Agreement No. CE 36/94
Reclamation and Servicing of
Tuen Mun Area 38 for Special
Industries - Improvement to
Roads and Junctions within Tuen
Mun Environmental Impact
Assessment :
*Environmental Impact Assessment
Report*

Agreement No. CE 36/94
Reclamation and Servicing of Tuen Mun Area 38 for Special Industries -
Improvement to Roads and Junctions within Tuen Mun
Environmental Impact Assessment Report
Final Report

ADDENDUM

FIGURE 5.5b - BARRIERS LOCATION FOR MITIGATION OPTION 2

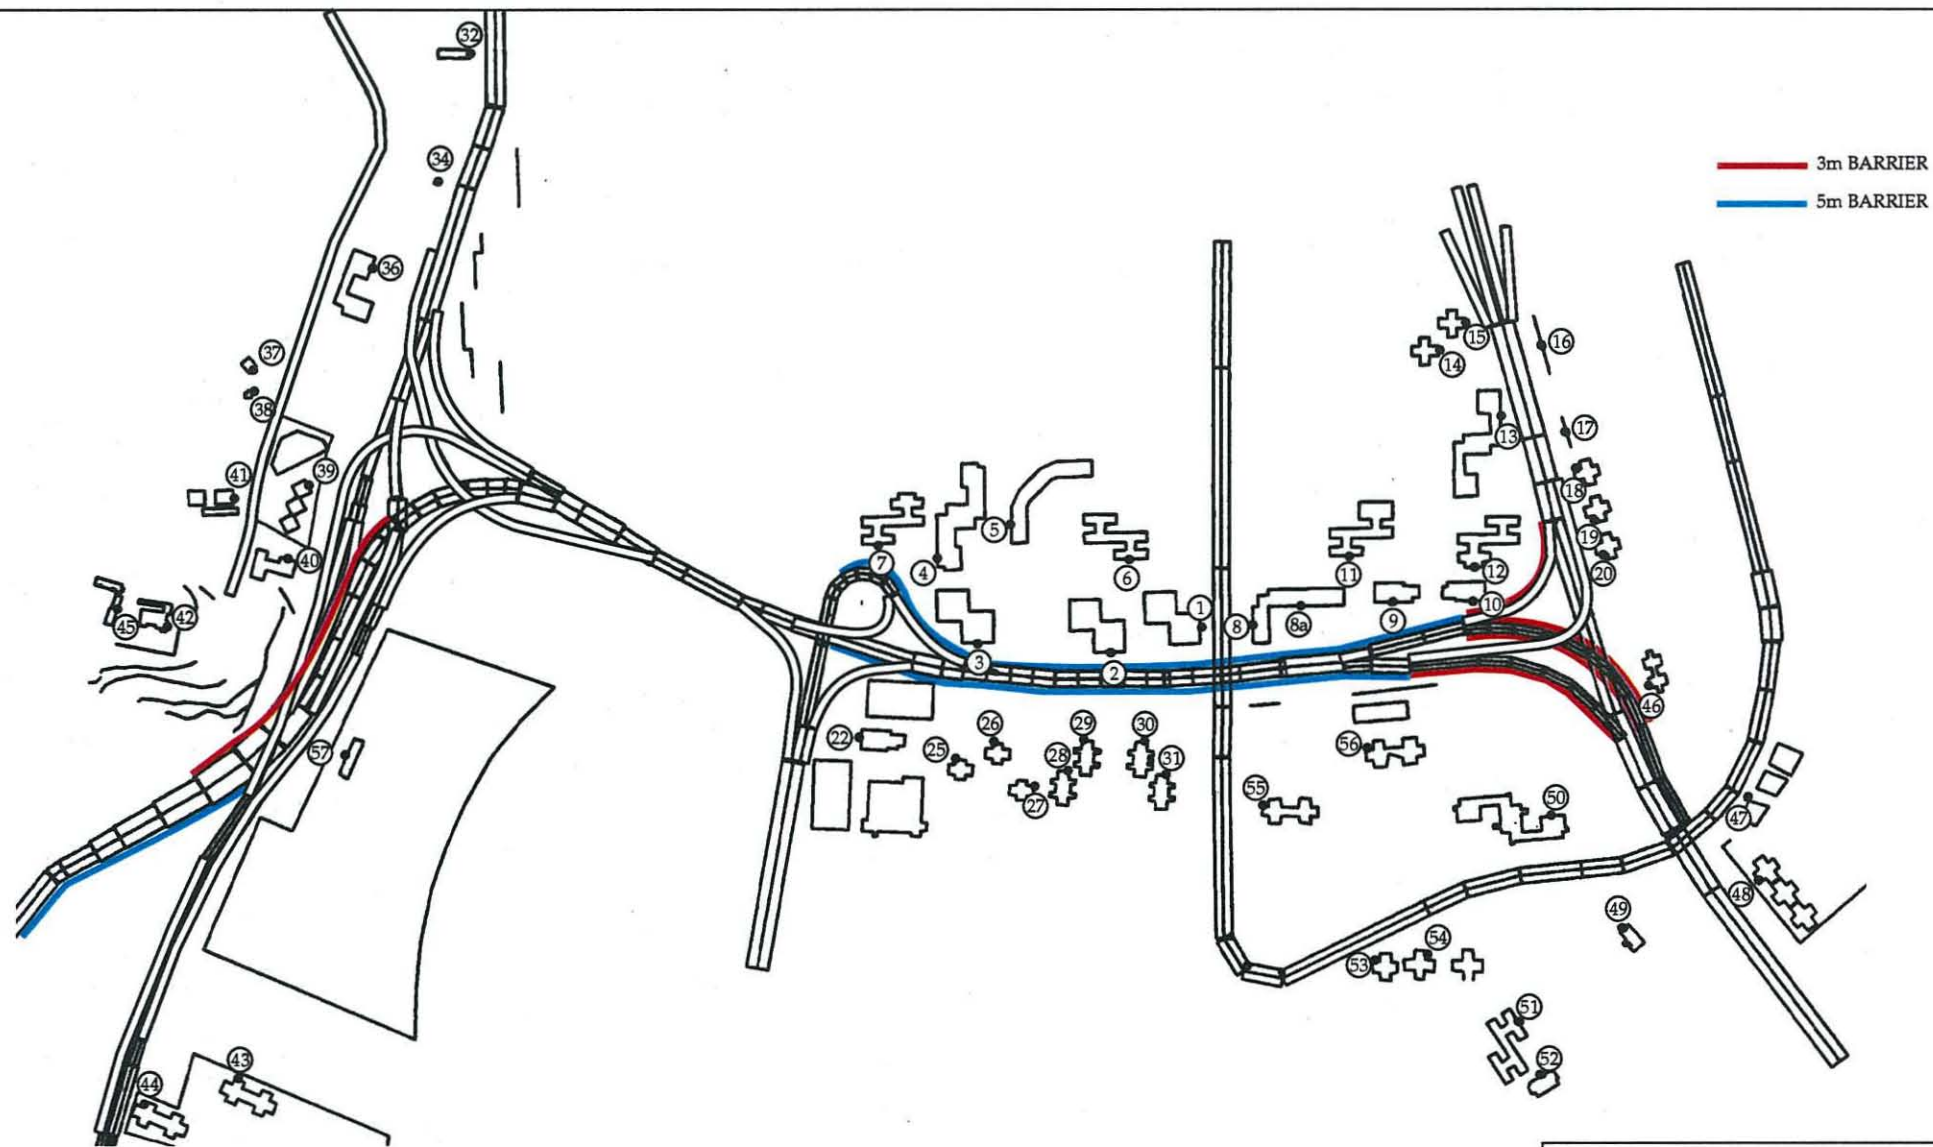
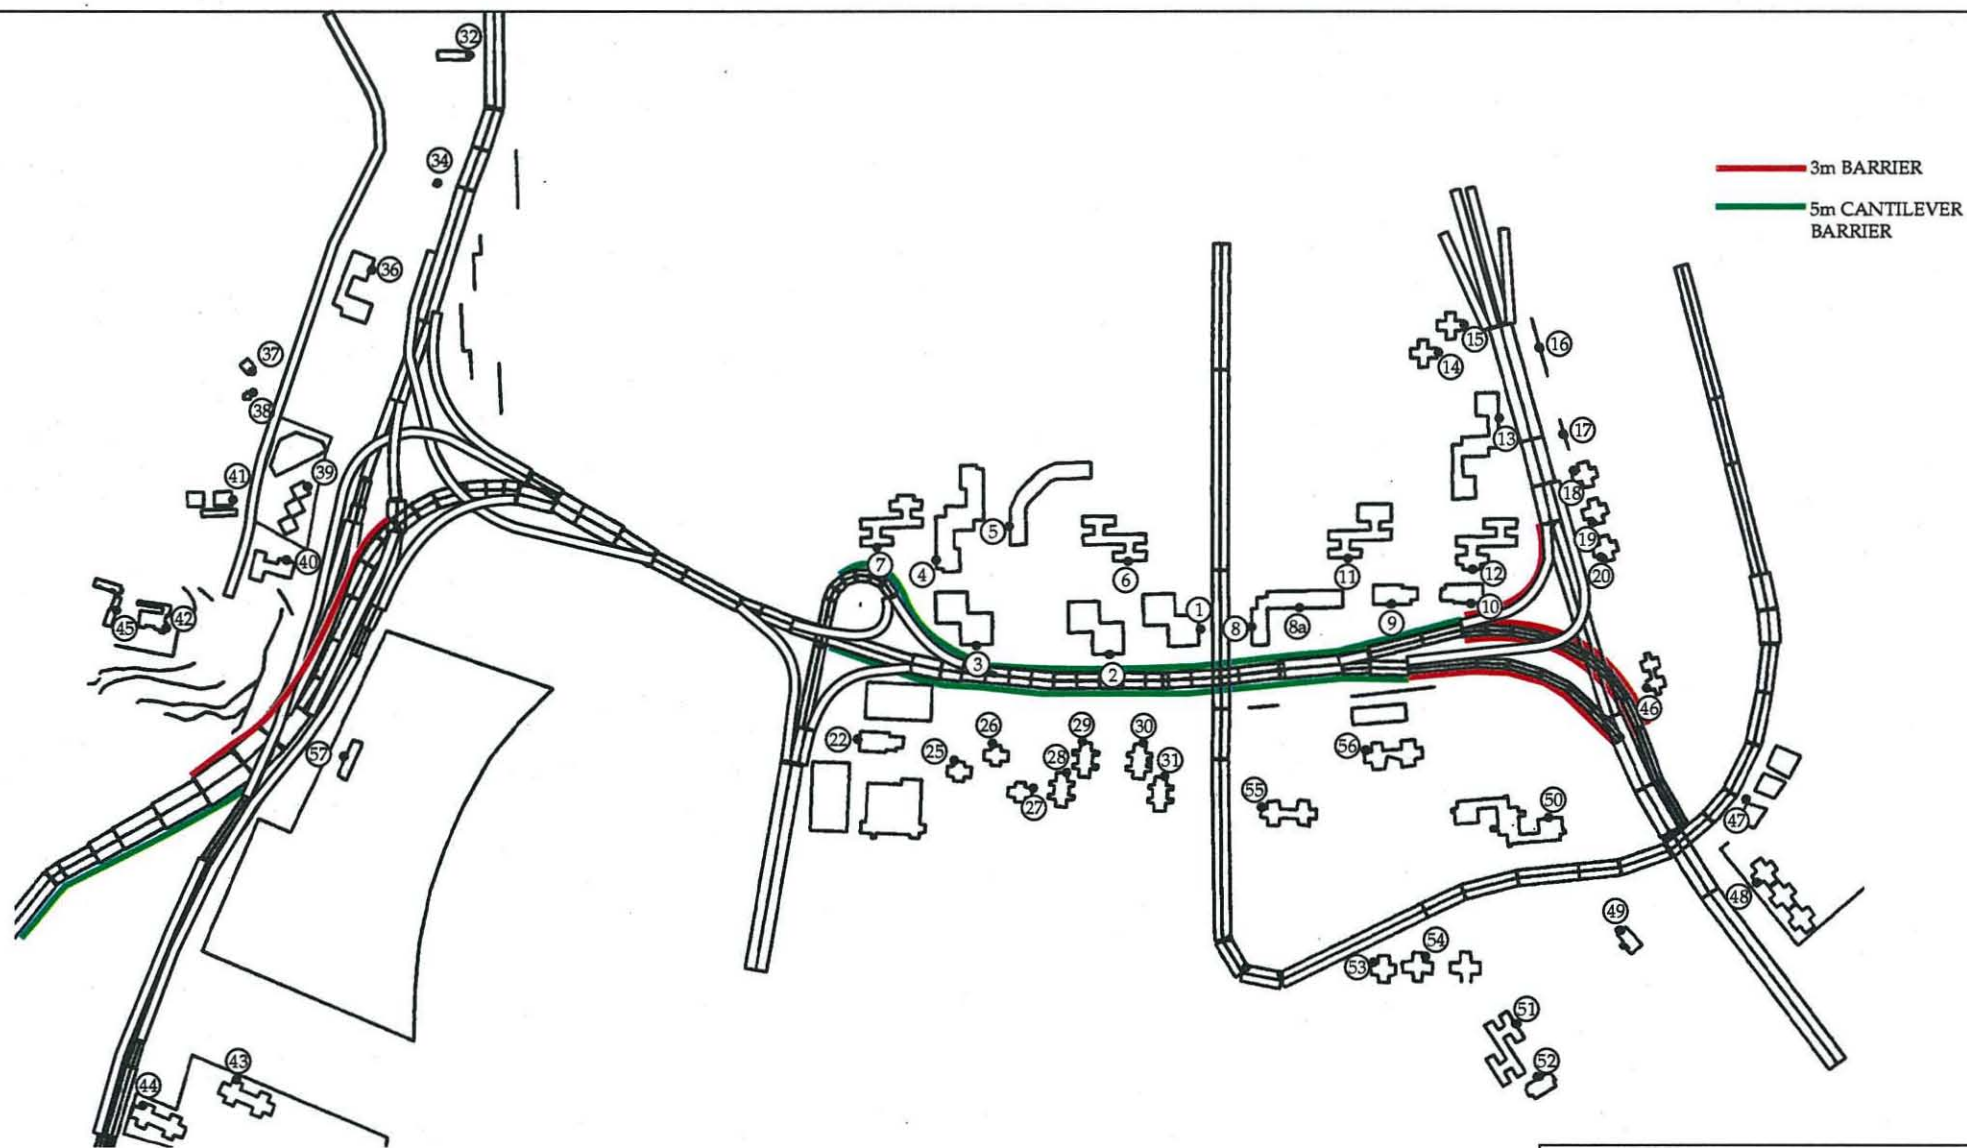
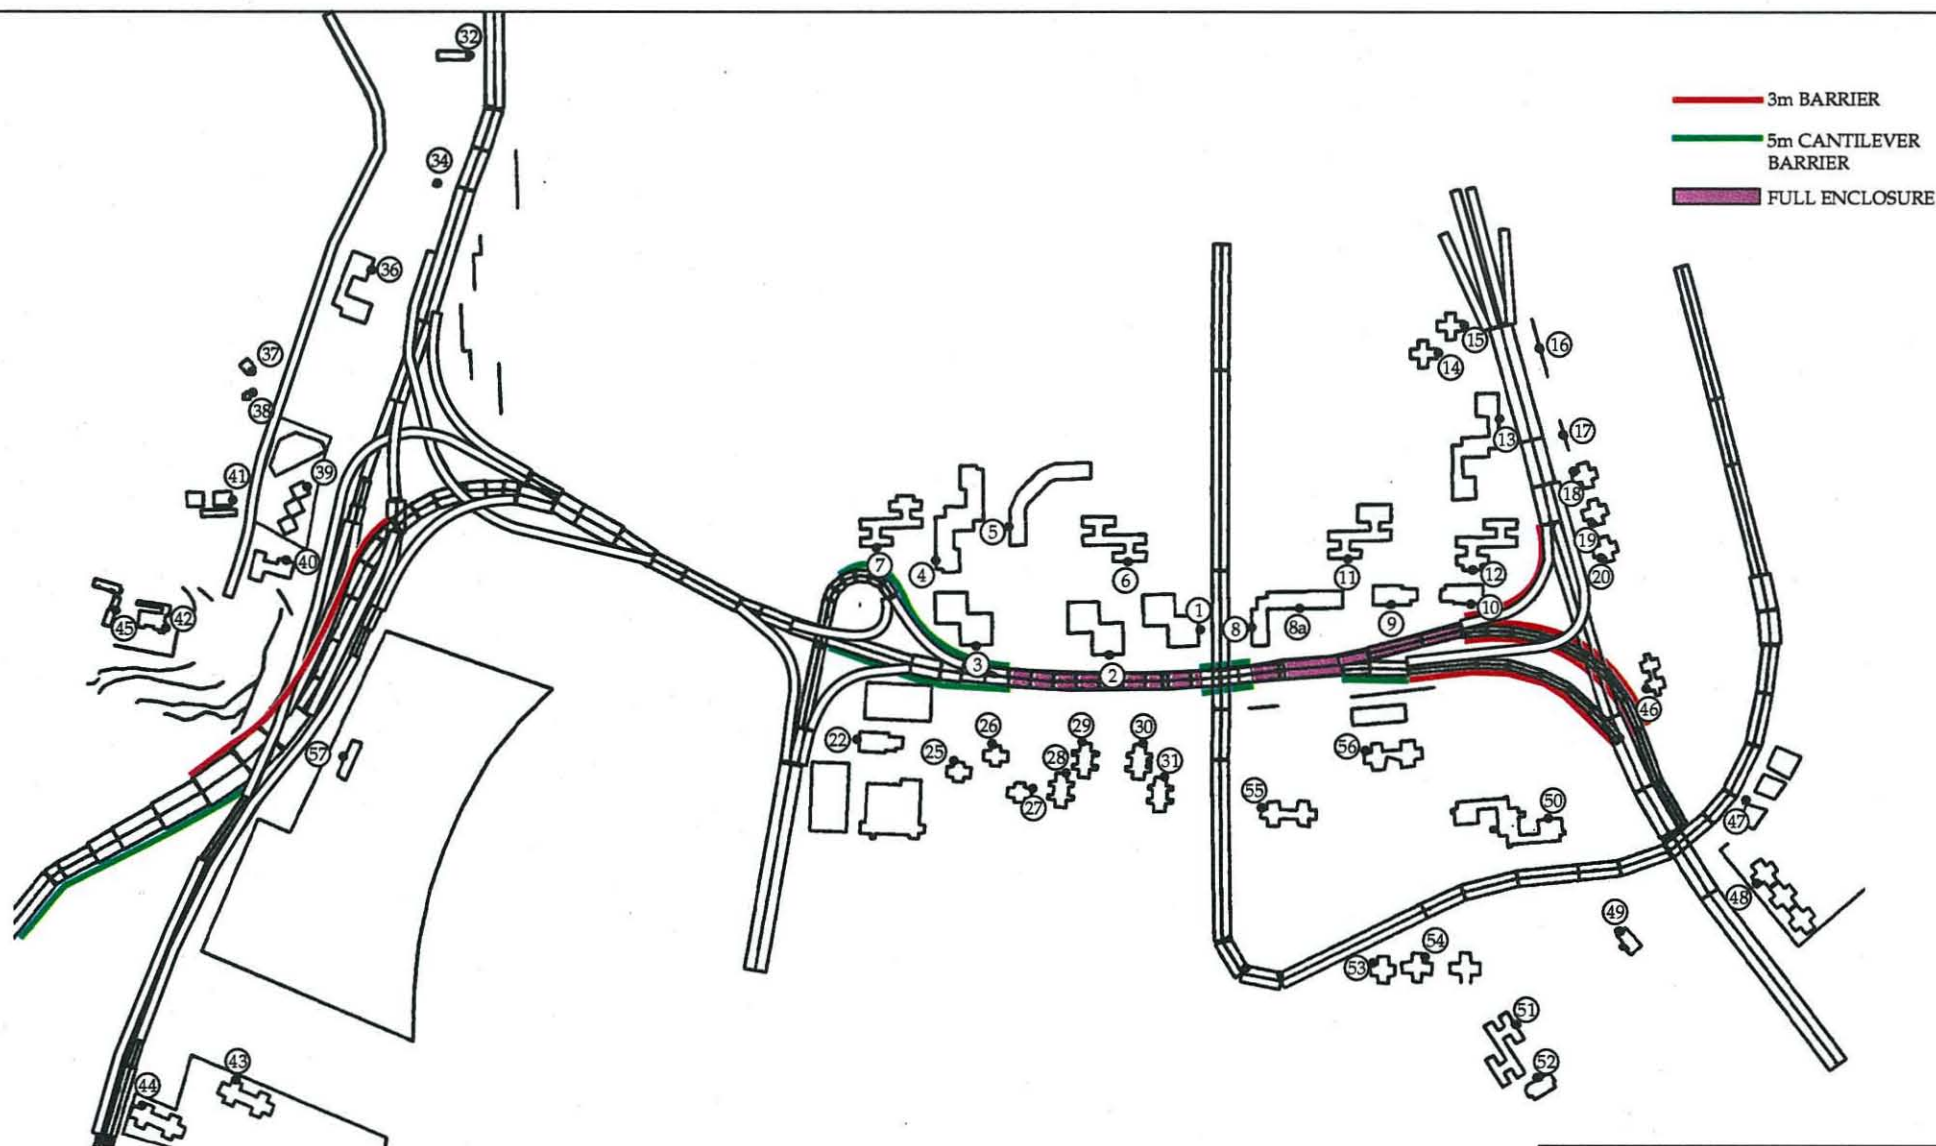
<p>(g) Figure 5.5a-c</p> <p>Some of the road sections are coloured black. What do they mean? Secondly, it will be useful if the "new" road sections for the purpose of noise modelling are shown on these figures.</p> <p>(h) Section 5.5 & Annex C Table 1</p> <p>Option 4 contains 2745 m² less of Low Noise Road Surface. Where are the savings?</p>	<p>Noted, see response to comment 52(h) above.</p> <p>The reduced area is due to the assumption that roads under enclosures will not need Low Noise Surfacing.</p>

FIGURE 5.6a - BARRIERS/CANTILEVERBARRIERS CONCEPTUAL DESIGN DRAWING

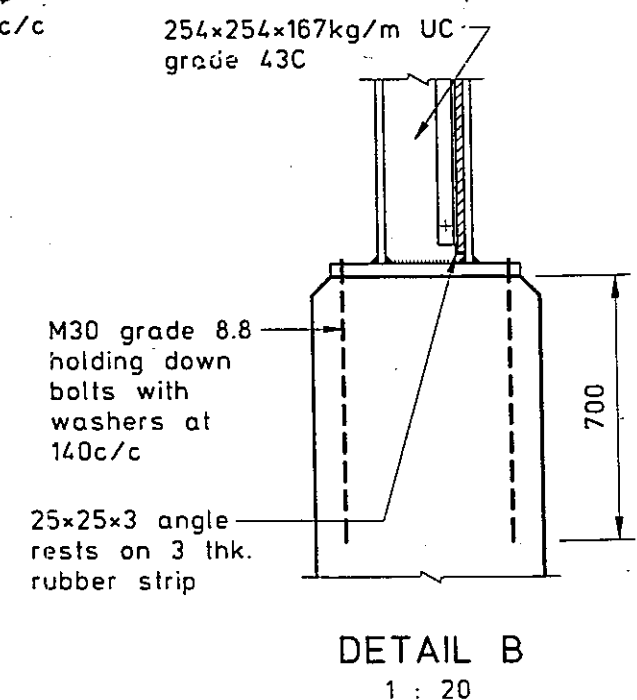
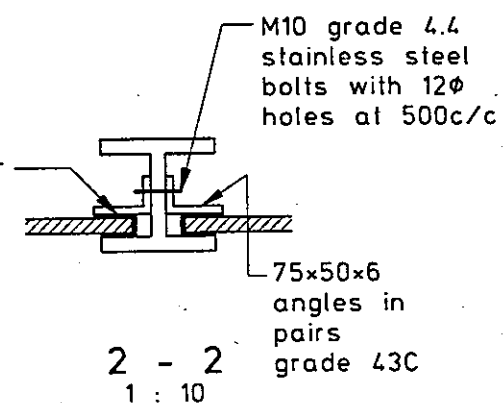
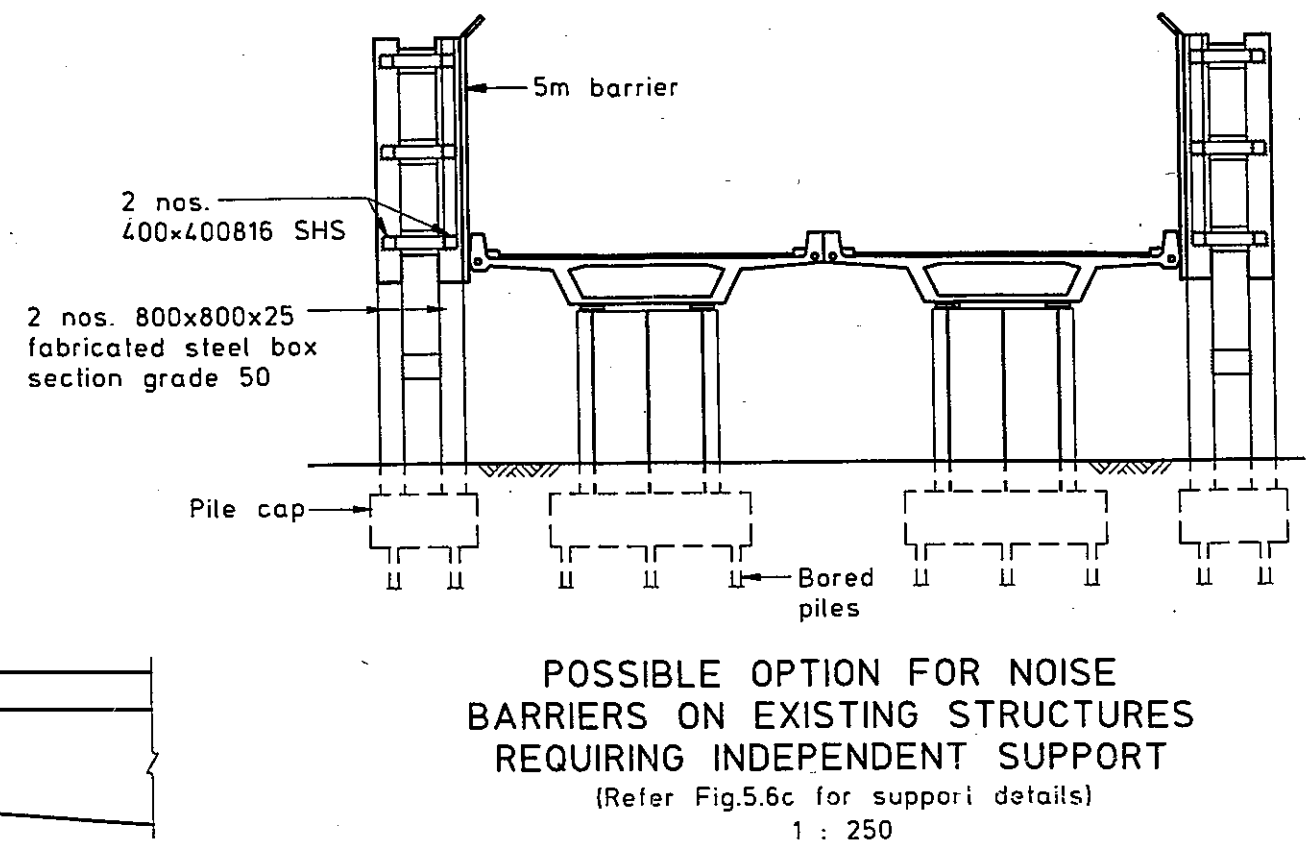
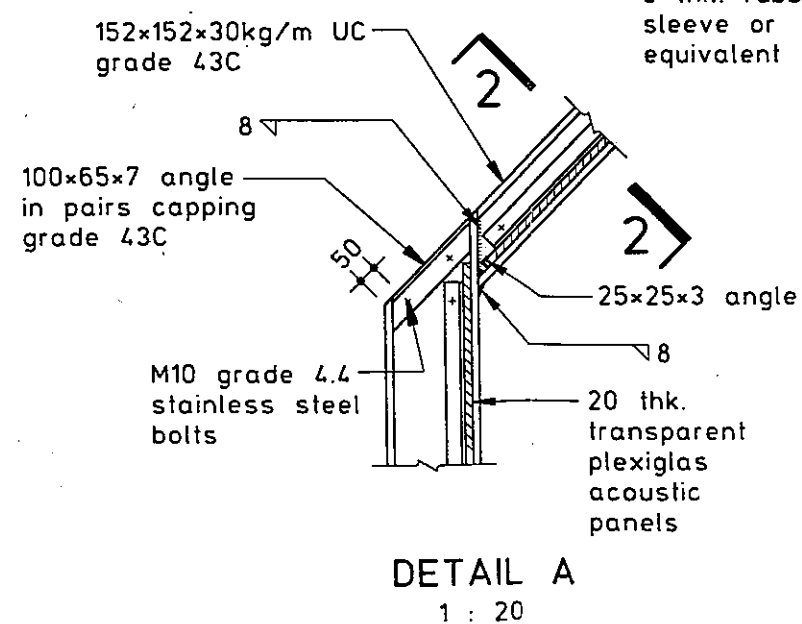
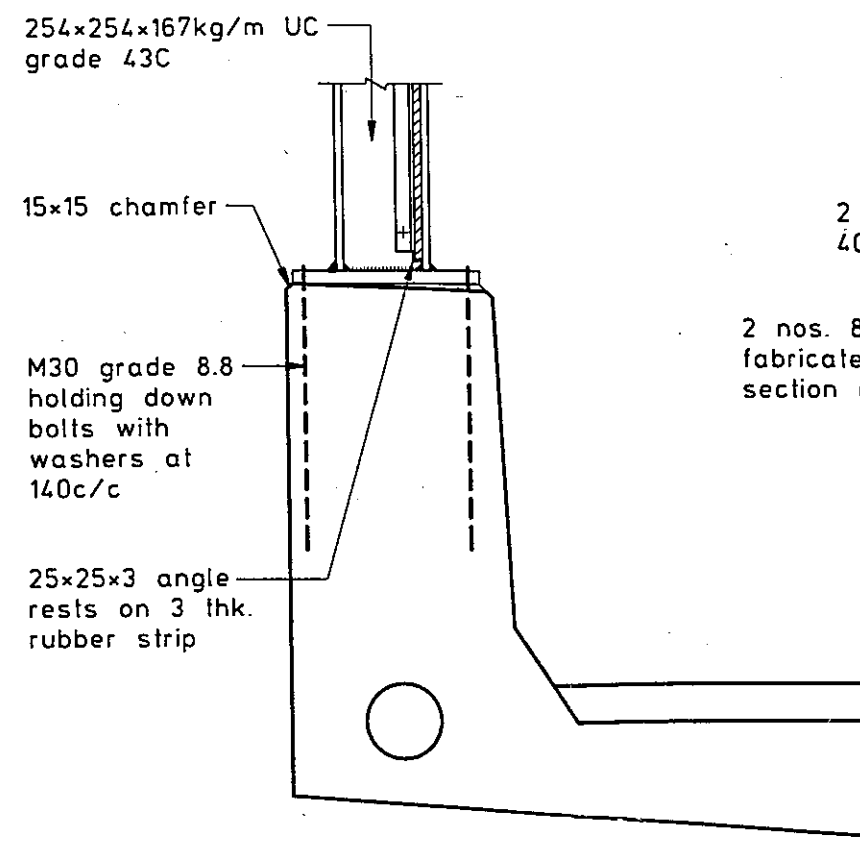
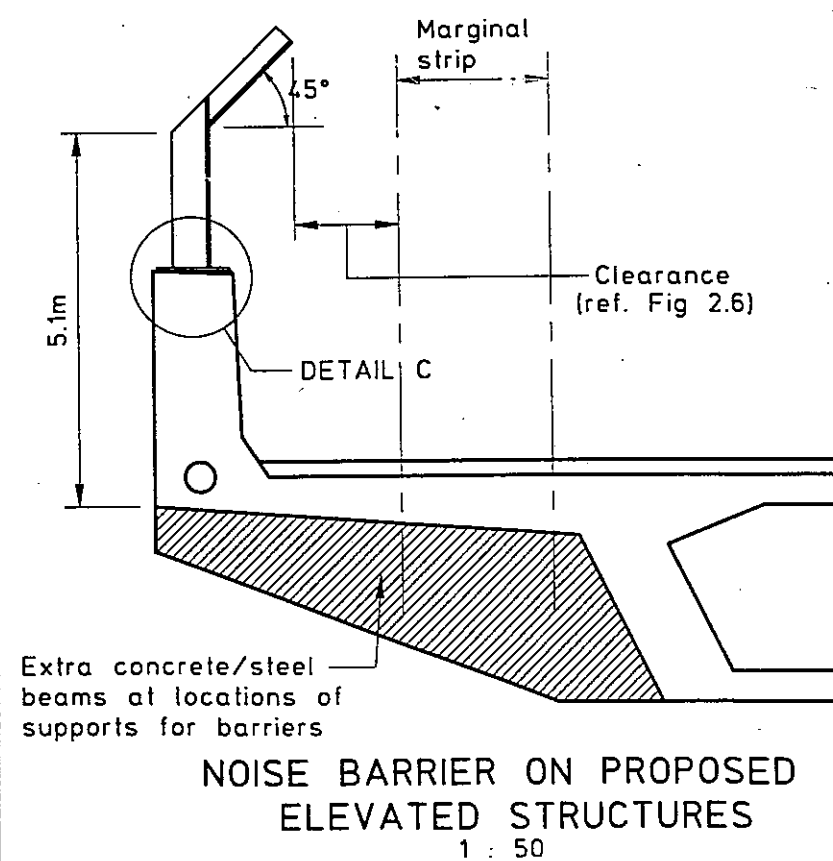
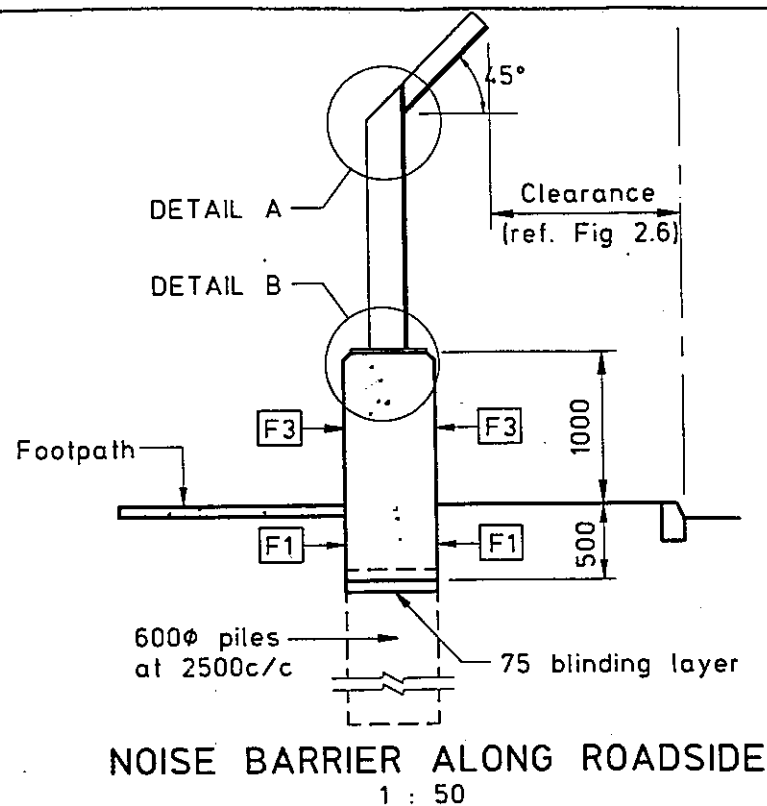
No.	Department	Reference	Comments	Consultants' Response
22			<p>(c) Proposed noise barrier (Fig 5.6a)</p> <p>i. I have reservation on the effectiveness of Detail C to minimise the colliding impact of vehicles with the design of the proposed plinth.</p>	Noted. Detail C in Figure 5.6a will be revised to a more substantial concrete plinth support for the barrier frame and will be proposed to be set back to minimize any adverse effect on resistance to colliding impact.
23			<p>ii. The arrangement of noise barriers along roadside is unacceptable. The gap between the slope and the wall will become a dumping corridor of rubbish. It is very undesirable to expose the pedestrian as using the footway to be bombarded by the traffic noise, which is exponentially exaggerated by reflection from the noise barrier. It is more appropriate to locate the footway outside the noise barrier, if technically feasible.</p>	Agreed. The arrangement of the noise barrier along roadside in Figure 5.6a will be revised to show the footway outside of the noise barrier.
